I, Fred C. Arfman, NMPE No. 7322 of the firm Isaacson & Arfman, P.A. hereby certify that this project has been graded and will drain in substantial compliance with and in accordance with the design intent of the approved plan dated 5-6-13. The record information edited onto the original design document has been obtained by Benjamin M. Aragon, NMPS No. 15268. I further certify that I or a member of my firm under my direct supervision have visited the project site on 04-02-14 and have determined by visual inspection that the survey data provided is representative of actual site conditions and is true and correct to the best of my knowledge and belief. This certification is submitted in support of a request for permanent Certificate of Occupancy.

AREAS OF MODIFICATION BETWEEN APPROVED DRAINAGE GRADING PLAN AND ACTUAL AS-BUILT

Albuquerque Public Schools
Mitchell Elementary School Cafeteria Addition
10121 Comanche Rd. NE
Albuquerque, New Mexico 87111

GRADING & DRAINAGE PLAN

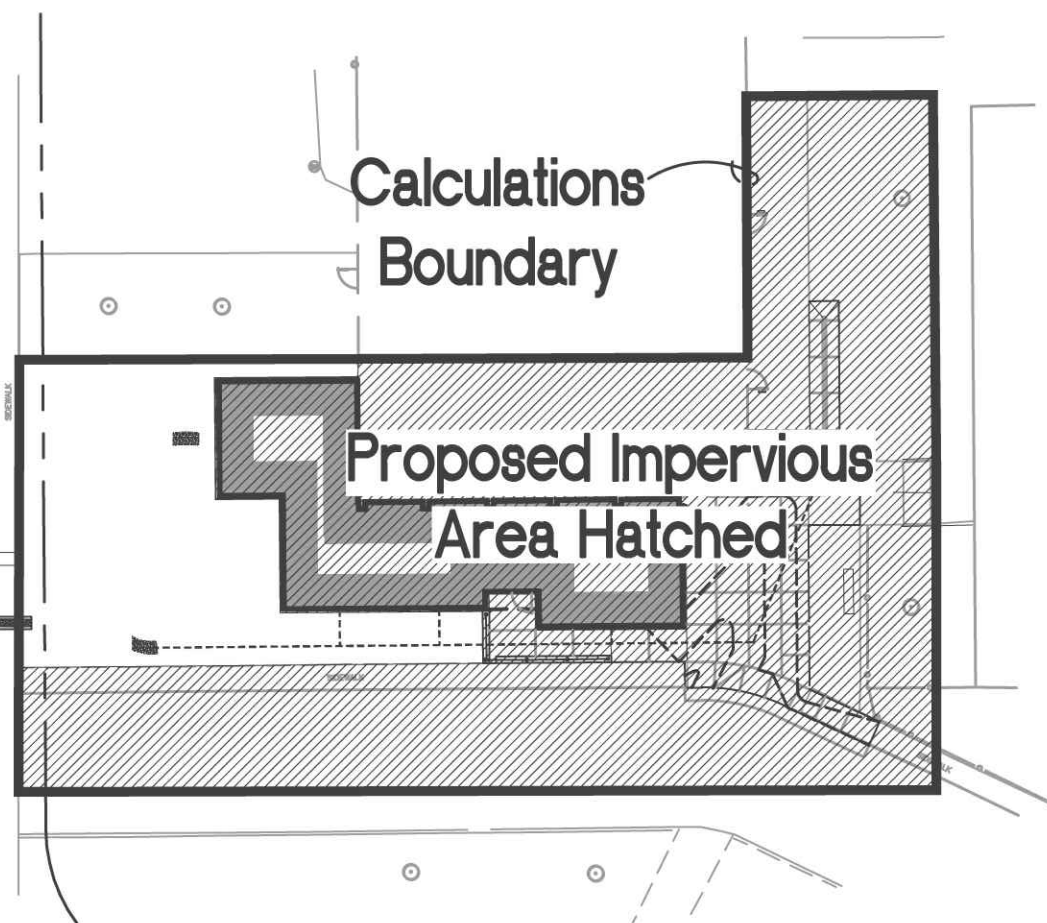
Landscaping rock swale with boulders constructed in place of grouted rock erosion protection (2 locations). Owner to maintain. OK
